URGENT: SAFETY NOTICE

<u>Diphoterine® and Hexafluorine® Portable Autonomous Showers</u>

Subject of the notice:

Prevor ref.: NC 23850

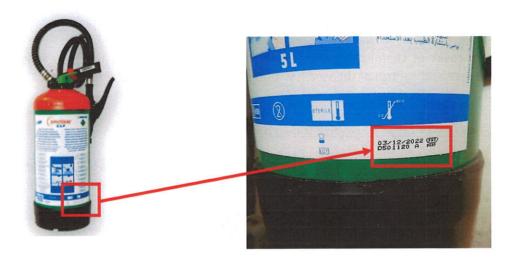
1. Check if the batch number of the hoses connected to your DAP devices is 1907

To read the batch number of the hose: lift the spring (photo 1) and read the 4 digits engraved on the metal part (photo 2).
